Subject: **Geotechnical Engineering Review No. 1
AF Crossing
6885 West 7300 North
American Fork Utah
American Fork Application No. 2018-106
TG Project No. 22032**

Submittal Status: **GEOTECHNICAL ENGINEERING SUBMITTAL INCOMPLETE**

**Re: Response to Review
American Fork Crossing
6885 West 7300 North
American Fork, Utah
Job No: 220061**

SITE PLAN SHOWING LOCATION FOR UPDATED MARCH 14, 2022 RECOMMENDATIONS

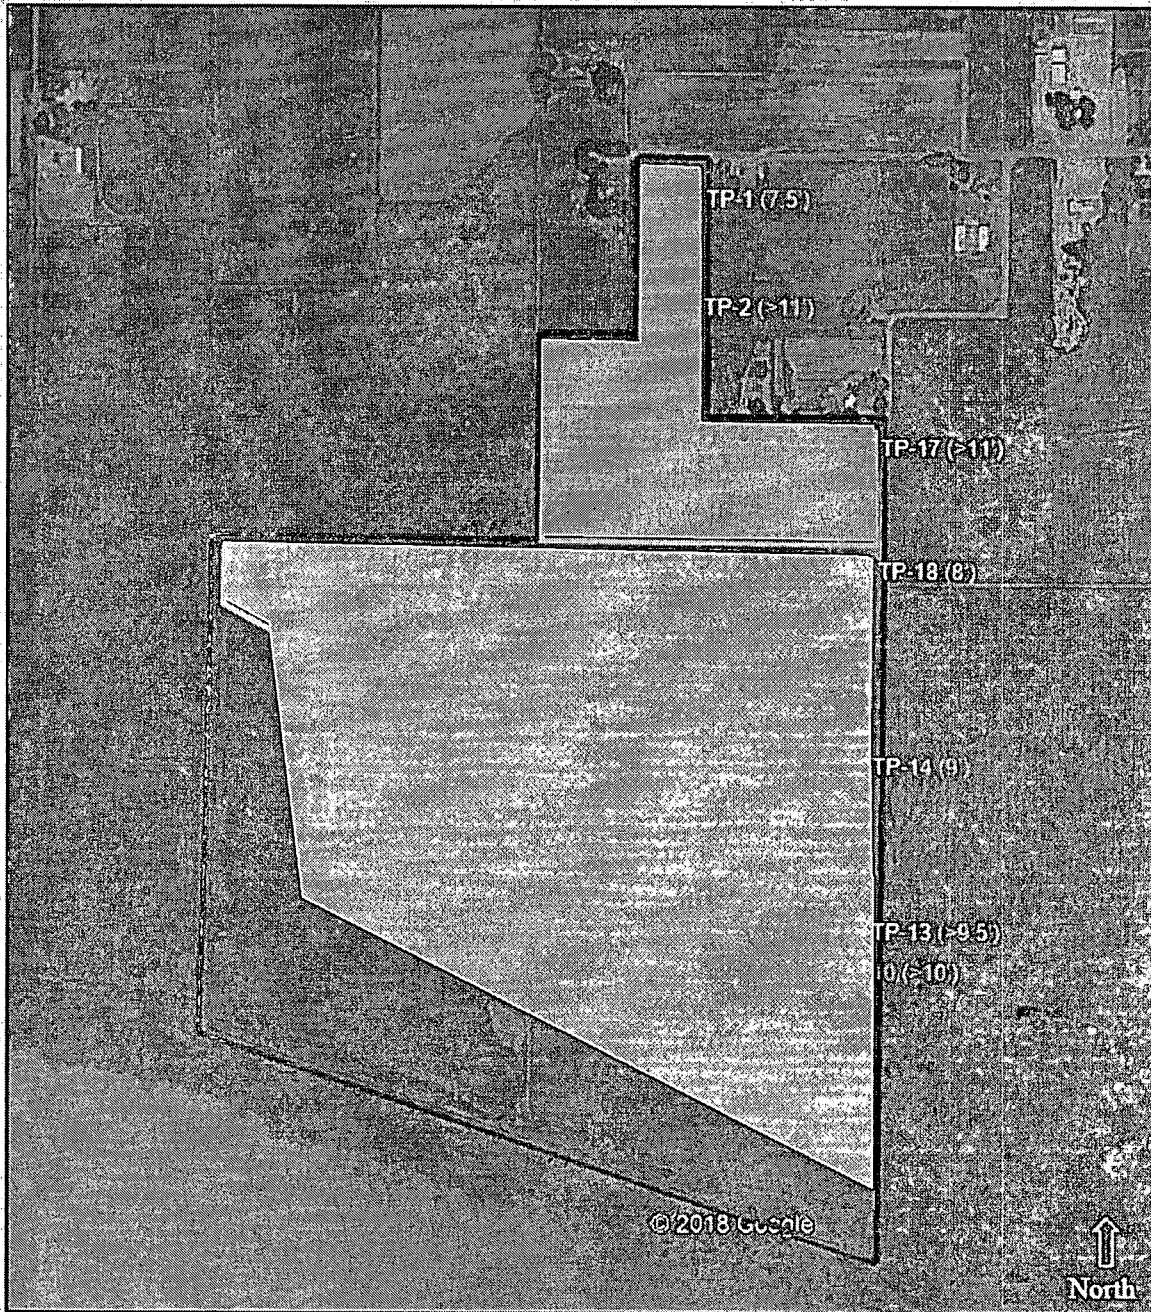
1. *TG recommends the City request EE to provide a site plan indicating the area the recommendations provided in the March 14, 2022, letter are applicable.*
2. Section 10.3 Estimated Settlements (page 12) of the June 7, 2019, EE document states, "If the proposed foundations are properly designed and constructed using the parameters provided above, we estimate the total settlements should not exceed one inch and differential settlements should be one-half of the total settlement over a 25-foot length of continuous foundation, for non-earthquake conditions. Additional settlement could occur during a seismic event due to ground shaking if more than 3 feet of grading fill is placed above the existing ground surface, if loading conditions are greater than anticipated in Section 2, and/or if foundation soils are allowed to become wetted."

1. TG recommends the City request EE to provide a site plan indicating the area the recommendations provided in the March 14, 2022, letter are applicable.

Site Plan is provided at the end of this letter.

- Unchanged – build on native soils
- March 14, 2022 Letter – build on 12" of structural fill for loads up to 2,500 psf
